# Conceptual Review Agenda

Schedule for 10/05/15 to 10/05/15

# 2039 Timberline Rd Drive-thru Restaurant

**Re:** 2039 Timberline Rd. - Drive-thru Restaurant

SITE PLAN CONCEPT - CONCEPT REVIEW 2133 TIMBERLINE ROAD 09.21.15

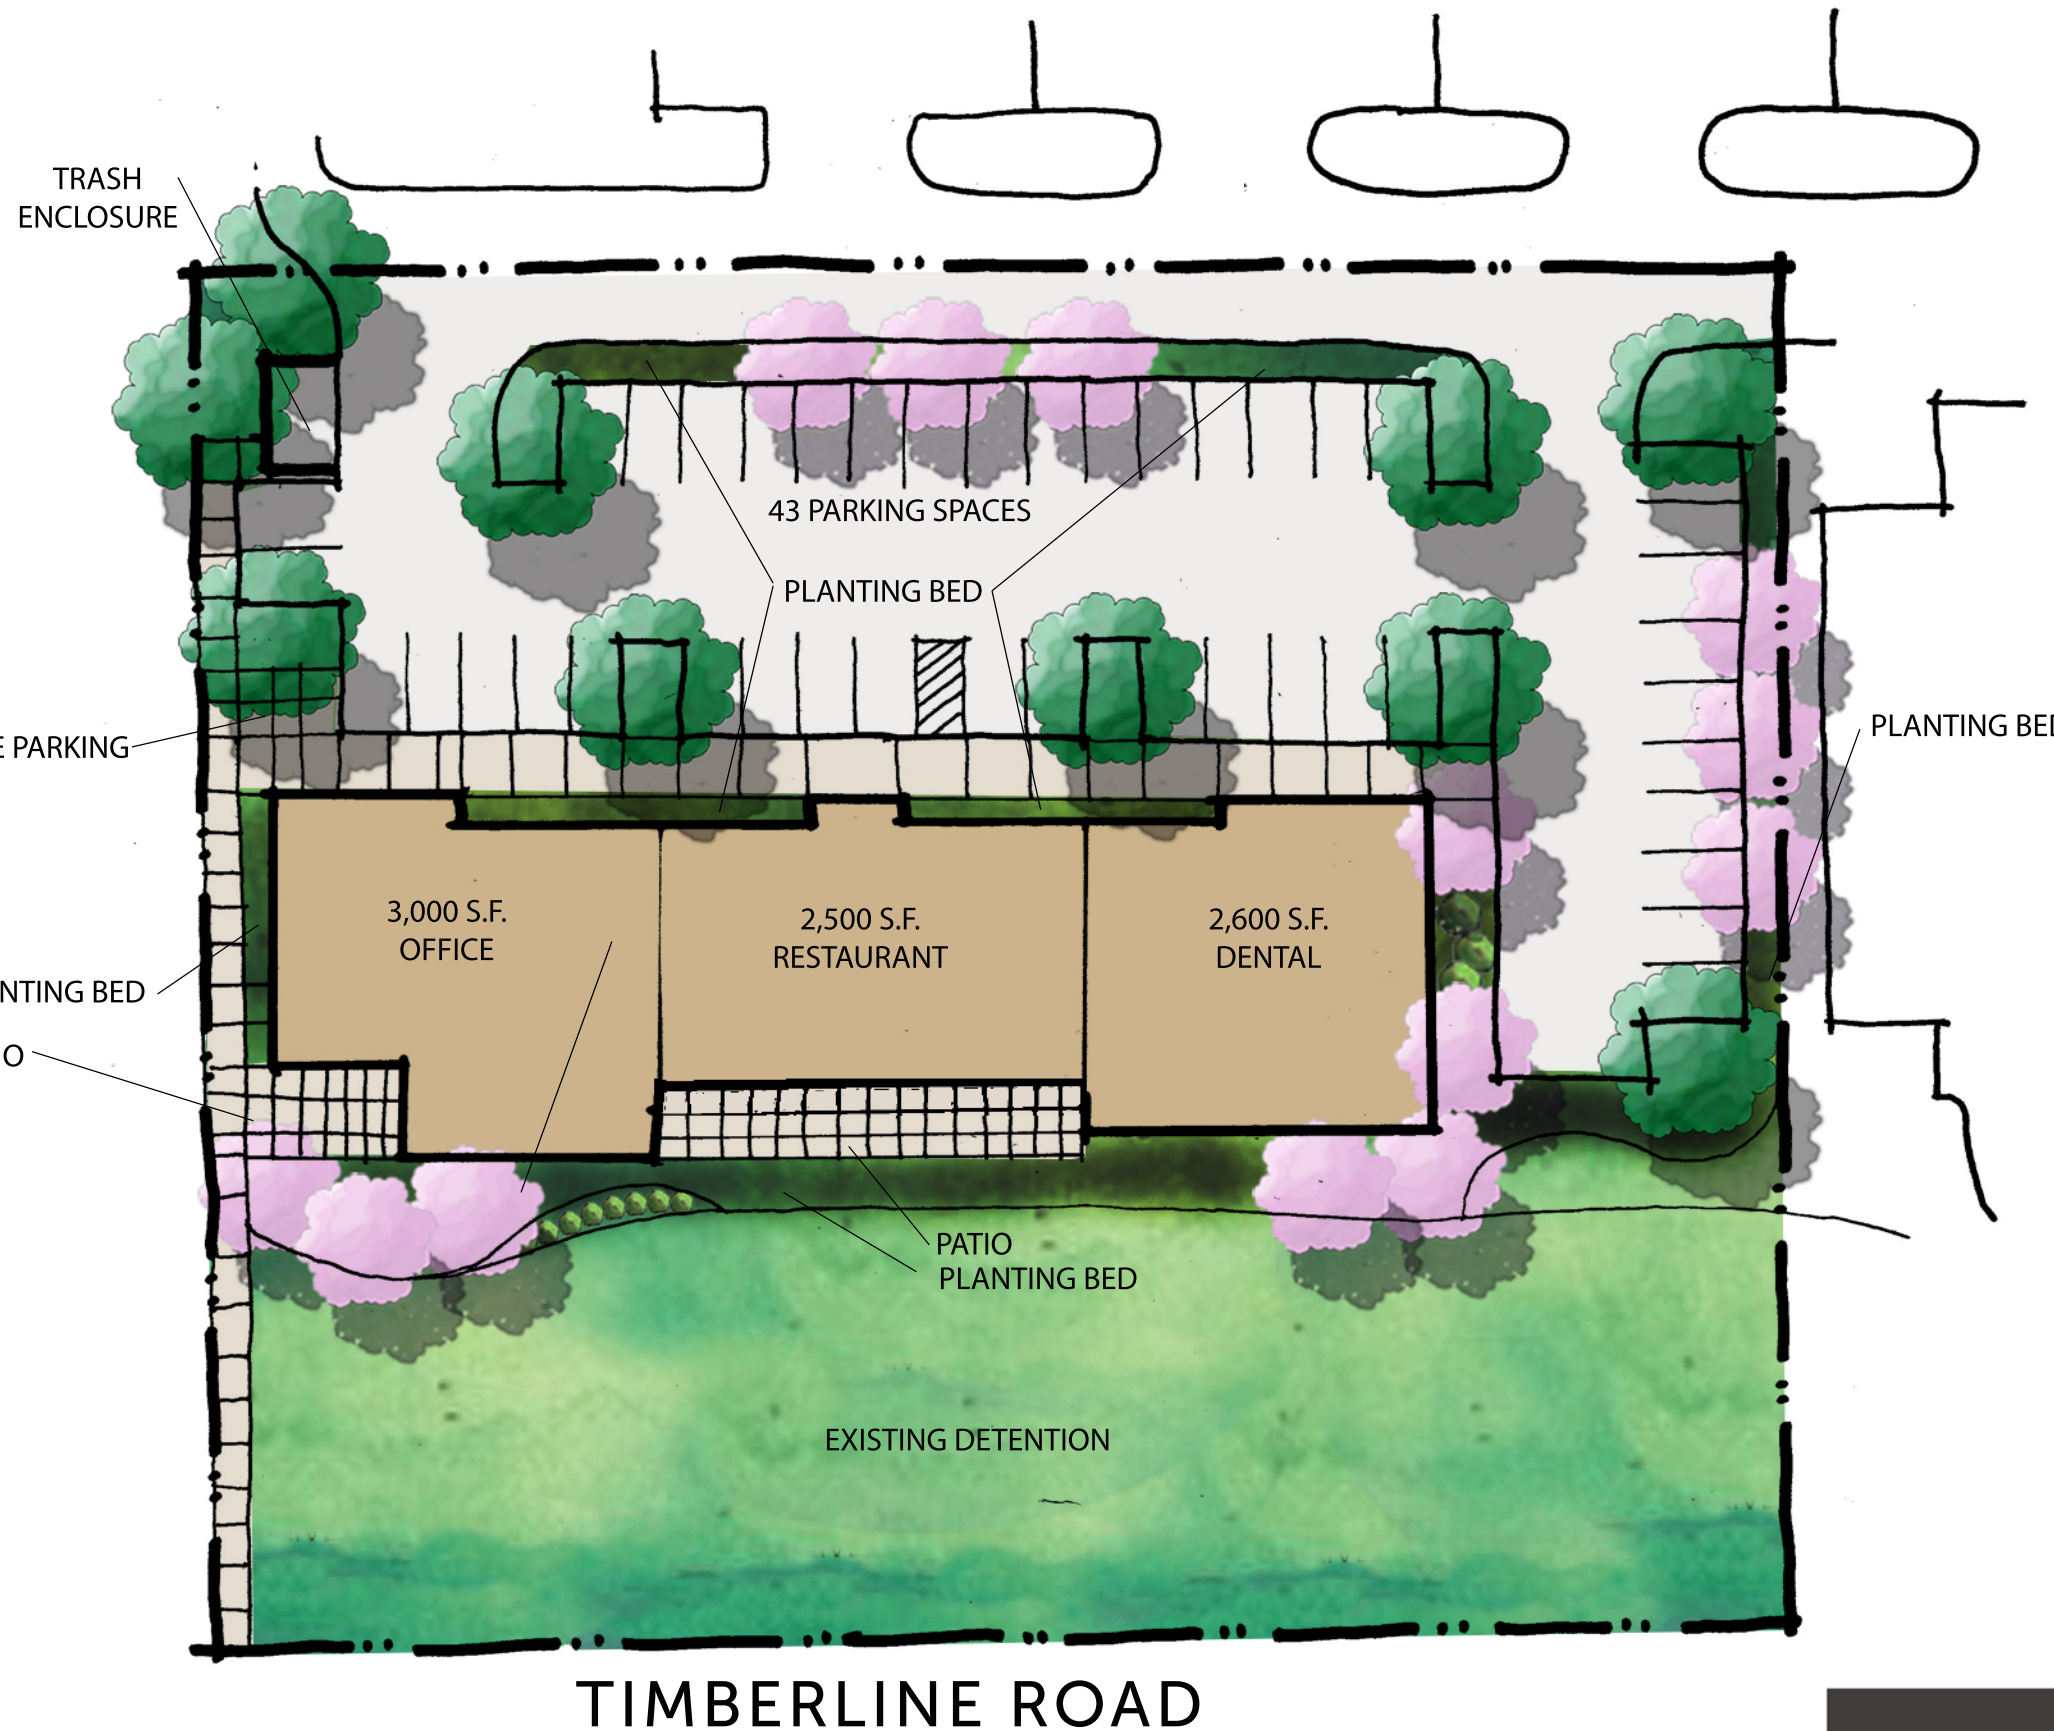
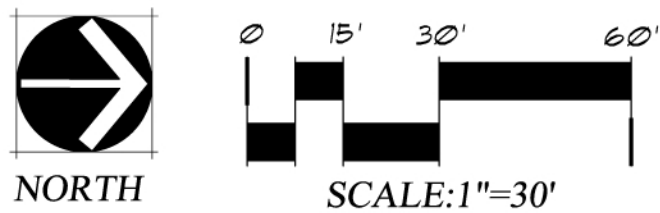
1. The site is Lot 11, Building J of the Timberline Center Final Plan. The parcel is zoned I, Industrial. The Final Plan designates this parcel as bank, with five drive-through lanes and walk-up A.T.M. The proposed uses are professional office and standard restaurant. An office is a permitted use subject to Administrative (Hearing Officer, Type One) review. A standard restaurant, however is permitted subject to Planning and Zoning Board (Type Two) review. Combined with the total re-design of the approved Site Plan, Landscape Plan and Architectural Elevations, the new program is considered a change of character thus requiring a Type Two review. Consequently, the request will be processed as a Major Amendment.

4. As point of emphasis with the aforementioned comment, if the east elevation is to be the location of utility meters, exterior ground-mounted equipment, exhaust fans, and the like, then solid screen walls will be needed. Simply landscaping these appurtenances has proven to be inadequate as demonstrated along Timberline Road south of Horsetooth Road. Screen walls must match the materials and pattern of the building. In addition, roof top mechanical equipment, if used, must also be screened from Timberline Road by a solid enclosure.

7. The architectural character for the Timberline Center was established by approval of the Final Plan. Please refer to sheet 4 of 8 which governs the broad parameters for all of the commercial buildings within the center. Exterior materials and colors are specifically indicated so that all 14 lots will be unified by a cohesive theme. For example, please note that roofs within the center, in addition to being pitched, must be colored either green or sage if metal, or tan or charcoal if asphalt shingle.

11. A landscape theme has been established along Timberline Road. Burger King, Big O Tire and Serious Texas Barbecue all feature tightly spaced Spring Snow Crabapple Trees flanked by Colorado Blue Spruce trees. This pattern must be continued along the east side of Lot 11. Please note that the Spruce trees may be of the pyramidal variety (Bakeri, Hoopsi) or the columnar variety (Iseli Fastigiata) rather than the full size Colorado Blue Spruce. Copies of these landscape plans are available. Please note that these species may be effective in screening the drive-through lane of the Burger King.

13. If the placement of the electrical transformer is visible from Timberline Road, then, as mentioned, it must be screened by a solid enclosure (meeting the proper clearance specifications) on three sides. On one side, the transformer must be within 10 feet of hard surface for emergency change-out without damaging landscaping.
